Submission in response to ACCC Consultation Paper

**OPTUS**

Variation to NBN Co Special Access Undertaking

August 2016

Figure 2 Updated NBN Product Construct under MTM model

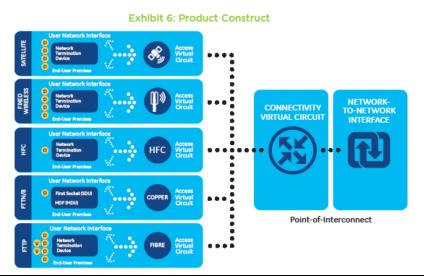
4.13 On the face of it, there would appear to be no need to alter the fundamental Layer 2 structure of the NBN product. The proposed changes, however, remove the intermediary

- elements between the network boundary points though still retaining the purpose of providing a Layer 2 service.
- 4.14 Optus submits that this does not provide clarity on the NBN Access Services covered under the SAU for a number of reasons. As a result, it is difficult to ascertain the definitive list of services to which the SAU applies. There is also the potential to unnecessarily capture NBN services that have yet to be developed. This does not increase certainty.
- 4.15 Optus has five main concerns with the proposed variations to the service description.
- 4.16 First, as defined in NBN Co's WBA-SFAA, the NBN Access Service is referred to as the NBN Co Ethernet Bitstream Service (NEBS) which NBN Co supplies to its customers.
